MEMORANDUM

Subject: **DESIGN RESPONSE CONFERENCE #2**
TOUCHSTONE (PARKPLACE)
FILE DRC09-00002

Touchstone's proposal is for design review of a 1.8 million sq. ft. mixed-use project that includes 1.2 million sq. ft. of office space and an additional 300,000 sq. ft. of retail. Other uses include a hotel and athletic club.

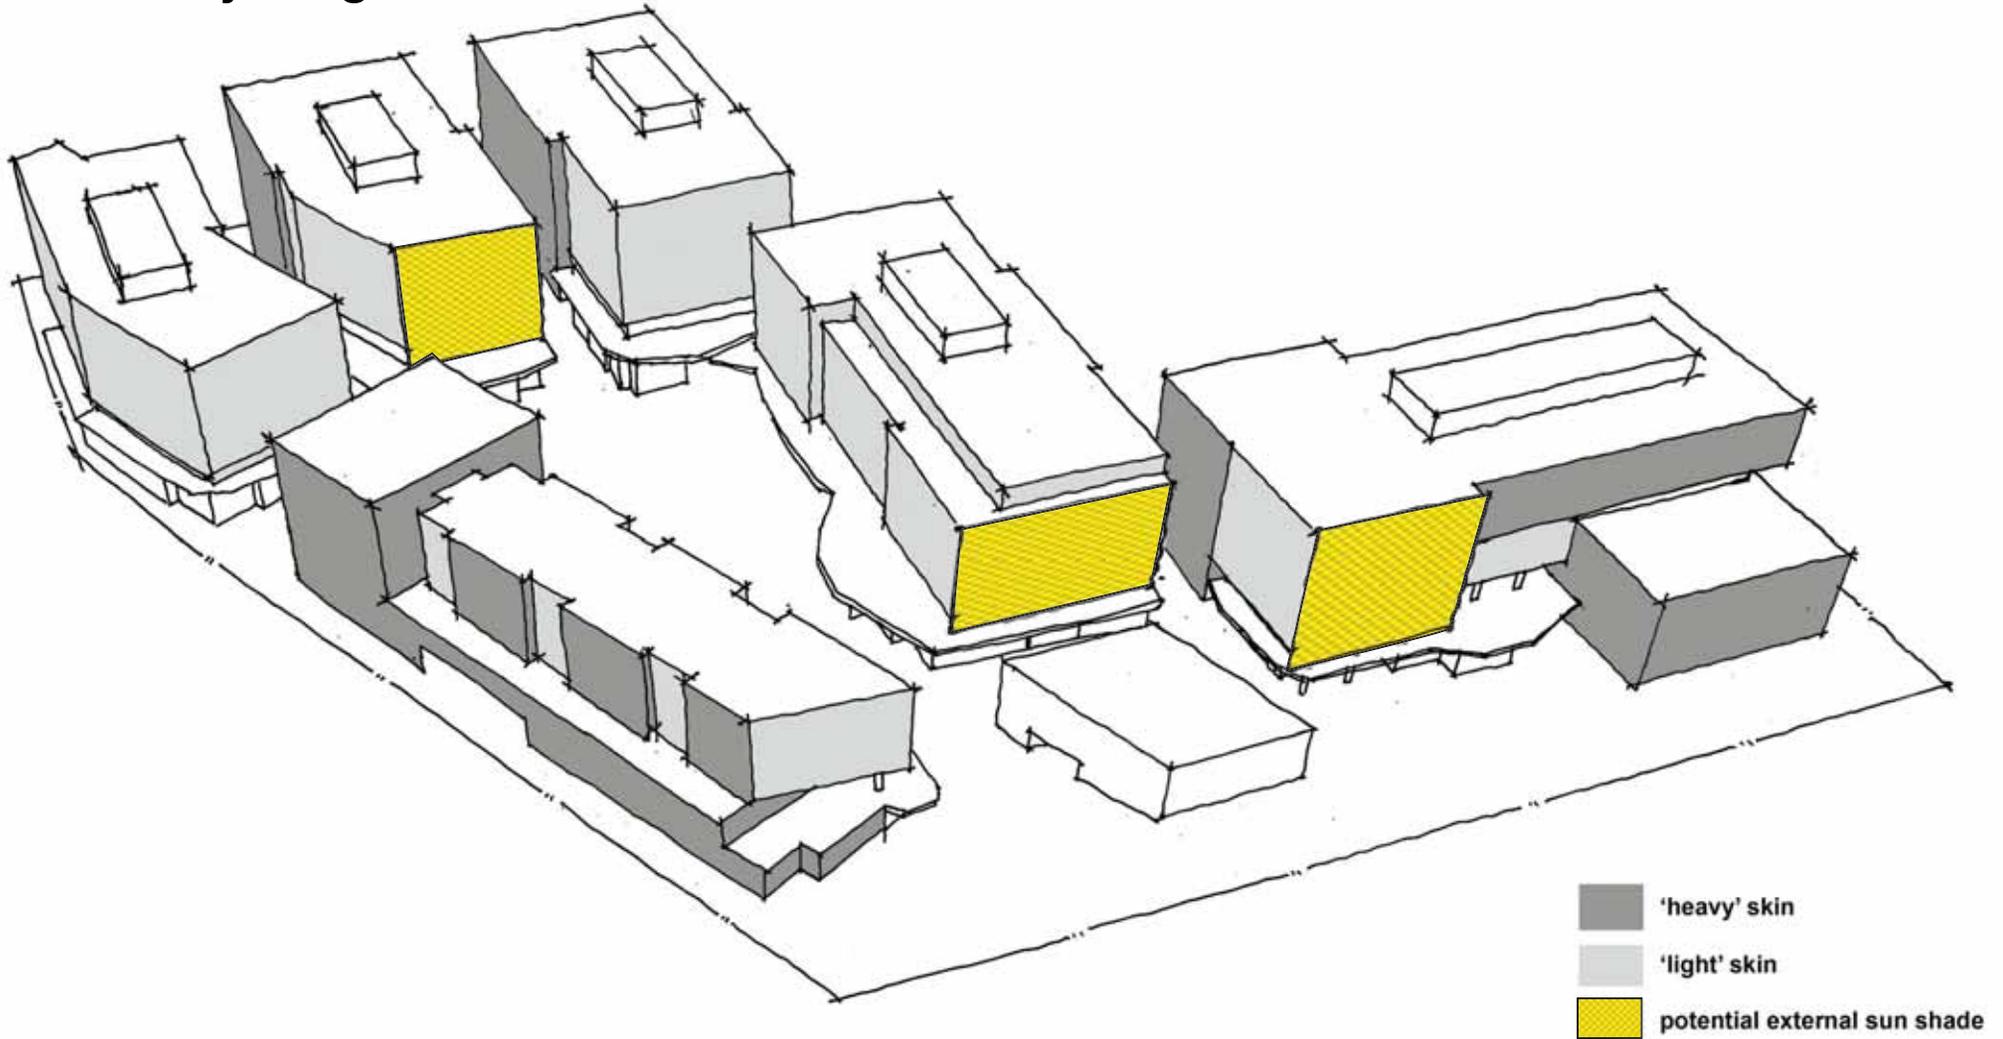
c. Building H- Provide development of the health club massing as well as development of Porte Cochere.

LMN will be providing development of Building H at a subsequent Design Response Conference.
